## **Access Compliance Report Public Rights-of-Way** (Curb Ramps)

Intersection ID: 10025367 Main Street: E\_8TH\_ST **Cross Street: N/A** Location: Ε

ADA ID: 77779A9022CF Ramp Type: Perp Initial Pass/Fail: Fail **Overall Compliance: No Severity Score:** 12.5

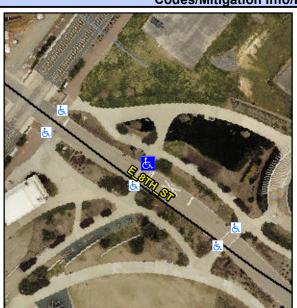
Possible Solutions: Remove & Replace Entire Ramp. Surveyor Notes: N/A PROW/ADA: R304.2.2

Comp	liance Description	Data	Comp	liance	Description	Data
N/A	Ramp Length (in)	112.0	No	Ramp	Slope (%)	9.3
Yes	Ramp Width (in)	64.0	Yes	Ramp	XSlope (%)	1.4
N/A	Flare Type LT	N/A	N/A	Flare	Type RT	N/A
N/A	Flare Slope LT (%)	N/A	N/A	Flare	Slope RT (%)	N/A
N/A	Flare Traversable LT?	N/A	N/A	Flare	Traversable RT?	N/A
N/A	Landing Length (in)	N/A	N/A	DWS	Provided?	N/A
N/A	Landing Width (in)	N/A	N/A	DWS	Contrast?	N/A
N/A	Landing Slope (%)	N/A	N/A	DWS	Length (in)	N/A
N/A	Landing X Slope (%)	N/A	N/A	DWS	Full Width?	N/A
N/A	Landing Curb? (Y/N)	N/A	N/A	DWS	Offset (in)	N/A
N/A	Shared Landing?	N/A				
N/A	Gutter Ponding?	N/A	N/A	Gutte	r Slope (%)	N/A
N/A	Gutter Lip Ht (in)	N/A	N/A	Gutte	r X Slope (%)	N/A
N/A	Painted X Walk1?	Yes	N/A	Paint	ed X Walk2?	N/A
	X Walk 1 Direction	To SW		X Wa	lk 2 Direction	N/A
N/A	X Walk 1 Width (in)	120.0	N/A	X Wa	lk 2 Width (in)	N/A
	X Walk 1 Slope (%)	0.3		X Wa	lk 2 Slope (%)	N/A
	X Walk 1 X Slope (%)	0.9		X Wa	lk 2 X Slope (%)	N/A
